## 92. Extensions of the Reconciliation Sublayer (RS) and Physical Coding Sublayer (PCS) / Physical Media Attachment (PMA) for 10GBASE-PR and 10/1GBASE-PRX for multipoint links and forward error correction

*Editors Note: Proposed Changes to c92.2.2 only - all other sections not effected by this proposal. Task Force decisions in resolution of this comment:*

**Primary Comment:** 193, 404

**Secondary Comments** included: 352, 353, 8, 82

**Figure 92–2—FEC Padding**

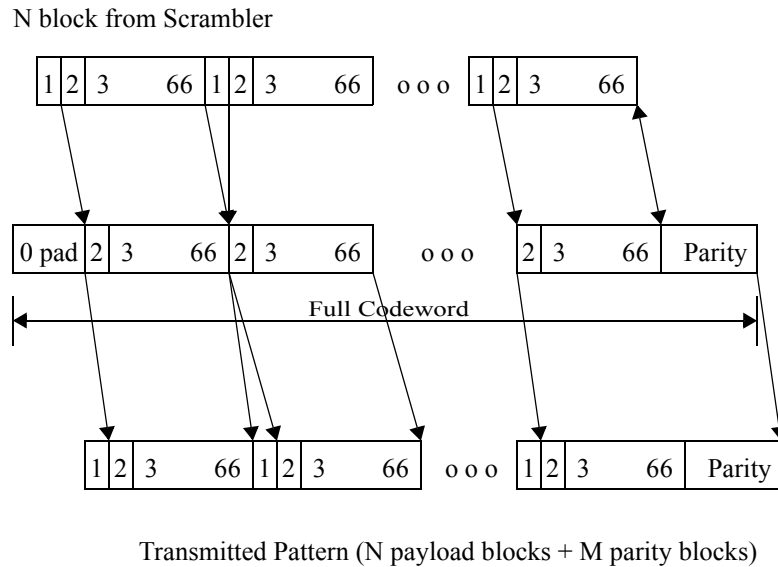
Padding of FEC codewords and appending of FEC parity bytes in the 10GBASE-RX PCS transmitter is illustrated in Figure 92–2. Ethernet packets are received from the PCS scrambler in blocks of 66 bits. The data is partitioned into 27 blocks. Each partition of 27 blocks is then encoded using the RS(255,223) FEC encoder, which results in an additional 4 parity symbols for each block. The block, minus any padding, plus the associated 4 parity symbols form the 233-byte FEC codeword. The additional 4 parity blocks, which are generated from this encoding process for each block, are gathered and added at the end of FEC codeword to be transmitted. note that parity is not calculated over the first bit of each 66-bit from the scramble as this bit is redundant. However this first bit is always transmitted over the link. The FEC encoder accumulates 27 66b blocks and removes the first bit of each block (ie. the redundant sync bit of the 66b word). The FEC encoder then prepends 29 "0" padding bits to the 27 blocks form the 233 byte data portion of a FEC codeword. The data is then FEC-encoded, which results in an additional 4 parity symbols for each block - completing the 255-byte Reed-Solomon codeword.

Figure 92-4—PCS Extension functional block diagram, US

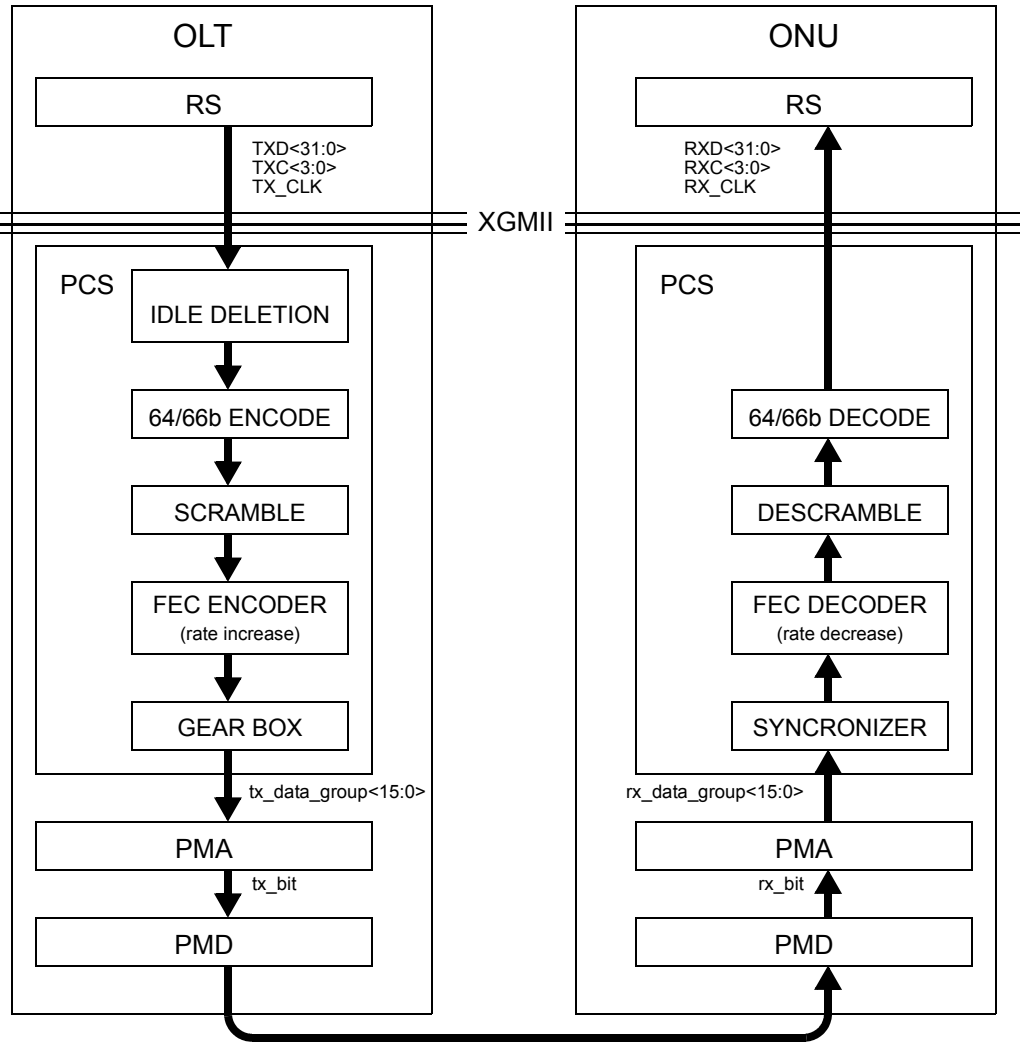
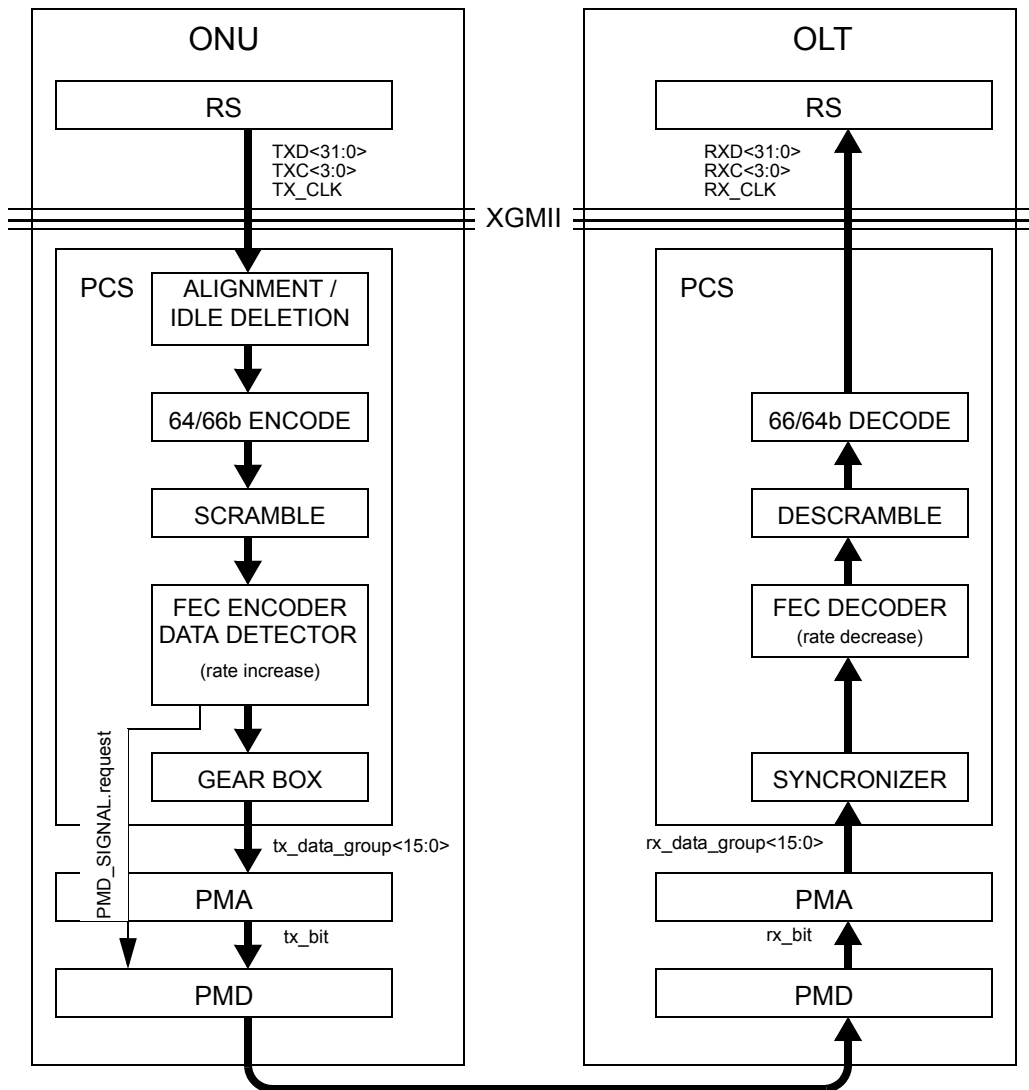
*Editors Note: Currently c92.2 includes two figures, 92-4 and 92-5, illustrating the PCS as OLT/ONT transmitter/receiver complementary pairs. These figures will be included in this Overview section with a short introduction added for each. It may be desirable to change the figures so they reflect 1) OLT PCS tx and rx 2) ONU PCS tx and rx. The TF must decide what is preferred:*

*Option 1a: Keep figures 92-4 and 92-5 as is; paired complementary transmitters and receiver.  
 Option 1b: Change figure 92-4 and 92-5 to illustrate OLT PCS (fig 92-4) and ONU PCS (fig 92-5).*

36 Upon initialization, the FIFO buffer is filled with ~~// ordered\_sets~~ idle control characters and the laser is  
37 turned off. When the first code-group that is not ~~// idle~~ arrives at the buffer, the Data Detector sets the  
38 PMD\_SIGNAL.request(tx\_enable) primitive to the value ON, instructing the PMD sublayer to start the  
39 process of turning the laser on (see Figure 92-4). {353}

Figure 92-5—Laser control as a function of buffer fill

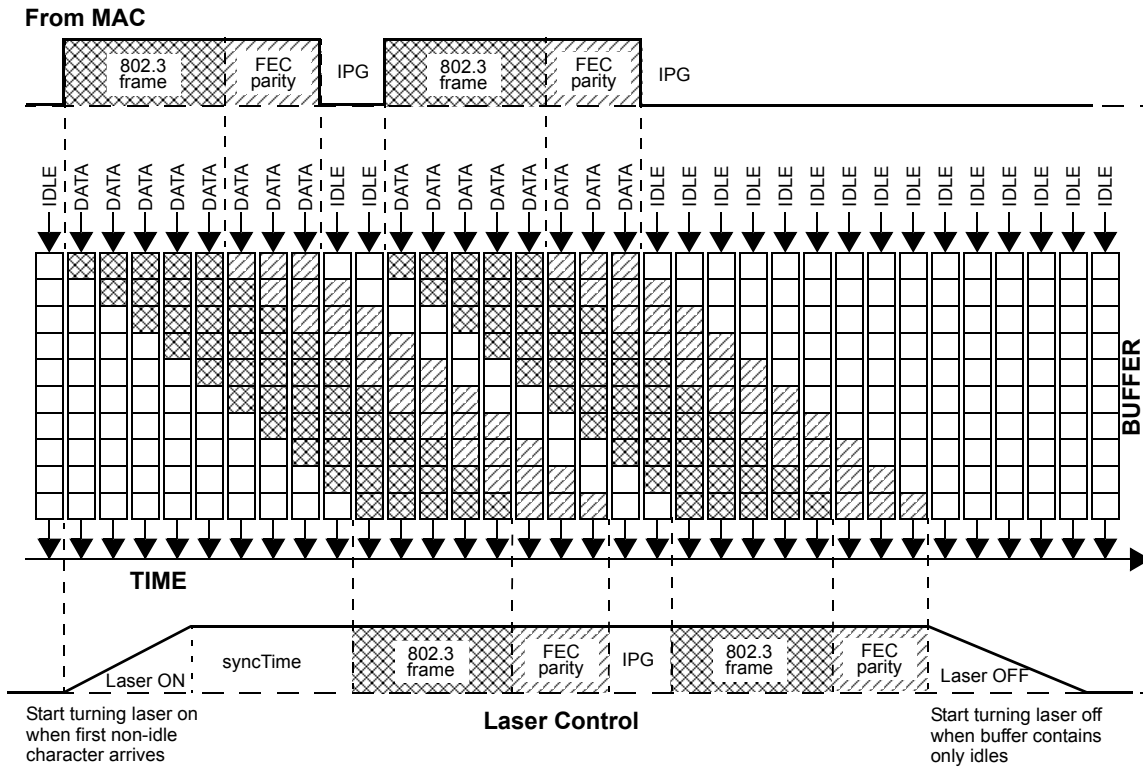
45 Figure 92-5 shows the relationship of filling the buffer and the generation of laser\_control. In the OLT, the  
46 laser always remains turned on. Correspondingly, therefore the OLT's Data Detector does not need a delay  
47 line or buffer in the data path for this purpose.  
48
